UNITED STATES PATENT AND TRADEMARK OFFICE

APPLICATION NO.	FILING DATE	FIRST NAMED INVENTOR	ATTORNEY DOCKET NO.	CONFIRMATION NO.
10/561,532	12/19/2005	Ronald Dekker	NL02 1153 US	9985

Office Action Summary	Application No. 10/561,532	Applicant(s) DEKKER ET AL.	
	Examiner Michael B. Shingleton	Art Unit 2815

DETAILED ACTION

Claims 1 and 9 are rejected under 35 U.S.C. 102(e) as being clearly anticipated by Matsumoto US 6,798,679 (Matsumoto).

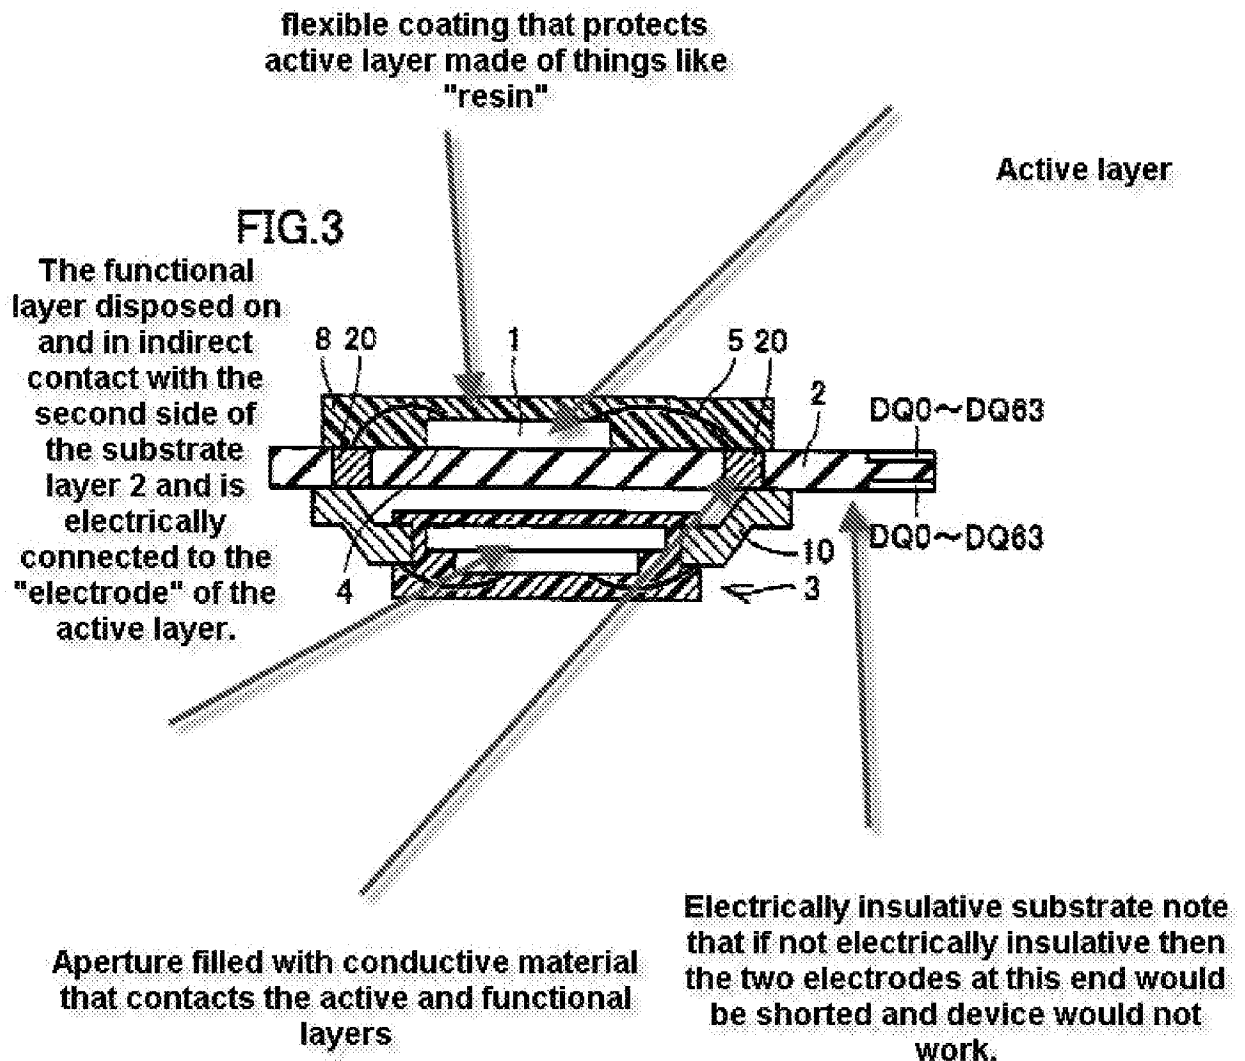
Claim 1 is so so extremely broad. First of all applicant still has not provided a proper drawing to an invention where the functional layer is on the "second side of the substrate". What applicant now points to as element 15 is composed of the same exact material as that of 14 with is pure conductor as presented by the original disclosure. This just cannot be the functional layer, period. Again what was shown in the original disclosure was that of pure conductor and thus there continues to be clear new matter that must be cancelled in response to this office action. However, as stated above claim 1 is so so so extremely broad. In essence claim 1 has a circuit on one side and a circuit on the other side of a substrate with a through hole connecting the two circuits. The only other thing added besides just stated is that there is a "flexible coating" formed on the "first side" of the substrate acting as a protective cover. Applicant should be well aware of the numerous flexible circuit boards that exist with through holes where the active or functional elements(layers) are mounted on both sides of the flexible circuit board and connected to each other via the through holes. More "rigid" versions like motherboards common in computers also are commonly known to exist with active and functional layers but all versions are flexible to some degree and applicant just has not claimed nor is there any support in the original disclosure to the degree, i.e. just how flexible is flexible as meant by applicant. The examiner wants to help applicant as much as possible to get to allowable subject matter and because there is no support for the degree of flexibility the examiner cannot

suggest a limitation as to the degree as this would introduce new matter into the specification that has already been plagued with numerous errors. Matsumoto has been provided to show that the invention as set forth in claim 1, notwithstanding the new matter that exists in the present application, is anticipated by the prior art. The following reproduced drawing should make it clear that claim 1 is clearly anticipated but a few points are discussed as well to further emphasize this point. Applicant says that the active layer includes "at least one switching element". Well many things can be considered a "switching element" and as Matsumoto intends to use memory chips as the active layer the memory devices contained therein can be called "switching elements" as there state i.e. a 1 or a 0 is switchable. Resin is clearly flexible and is listed as one of the "flexible materials" by applicant. The term "monolithic" is likewise very broad. Clearly even applicant's invention is not "formed from a single crystal". Applicant's invention it is like that of Matsumoto "consisting of or constituting a single unit" i.e. monolithic. Should applicant like to have the examiner read a term like "monolithic" much more narrowly than is common practice then applicant should be aware of the recent case-law of *Halliburton Energy Services, Inc v M-I LLC*, Fed. Cir, 2007-1149 that states: **"[b]ecause claims delineate the patentee's right to exclude, the patent statute requires that the scope of the claims be sufficiently definite to inform the public of the bounds of the protected invention, i.e., what subject matter is covered by the exclusive rights of the patent. Otherwise, competitors cannot avoid infringement, defeating the public notice function of the patent claims."** As recited in the above Halliburton decision the court says **"We note that the patent drafter is in the best position to resolve ambiguity in the patent claims, and it is highly desirable that the patent examiners demand that applicants do so in appropriate circumstances so that the patent can be amended during prosecution rather than attempting to resolve the ambiguity in litigation."** Also note that the Halliburton decision relates to the situation where applicant is very specific as to specific limitations on structure that has already been "seen" and then the claims seem to recite functional language "at the exact point of novelty". Many times these types of claims are indefinite. Again the Halliburton decision states: Claims could be held indefinite **"when the inventor is painstaking when he recites what has already been seen, and then uses conveniently functional language at the exact point of novelty"**. The Halliburton decision recited two Supreme Court cases that "identified the dangers of using only functional claim limitations to distinguish the claimed invention from the prior art" and these are *General Electric*, 304 U.S. at 371 and *United Carbon*, 317 U.S. at 234. What is needed in this application is clear limitations to positive structure in the claims that can distinguish the claimed invention over the prior art, i.e. the claimed positive limitations to structure that
